FX7500 2.3.14 Release Notes

Release Notes for FX7500 V2.3.14

Released on 03/Feb/2017

Allow/disallow Guest User

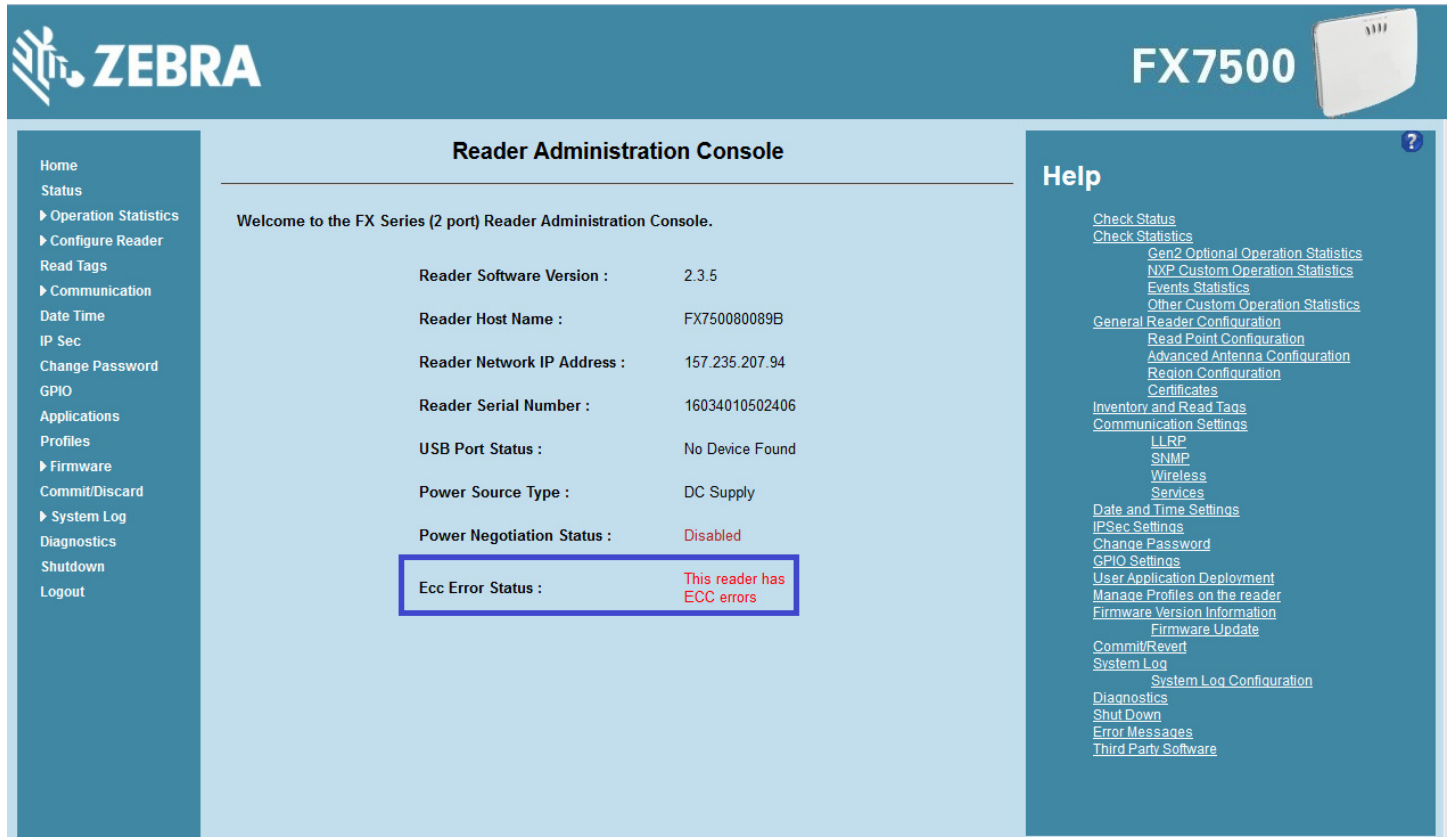
Option to control whether Guest User is allowed or not to access the reader.

- Allow Guest User** - Option to control whether Guest User is allowed or not to access the reader using the web console. When Checked (default) this option is enabled and Guest user is allowed to login to view the reader settings. Disabling this option prevents Guest user login to the reader's web console.
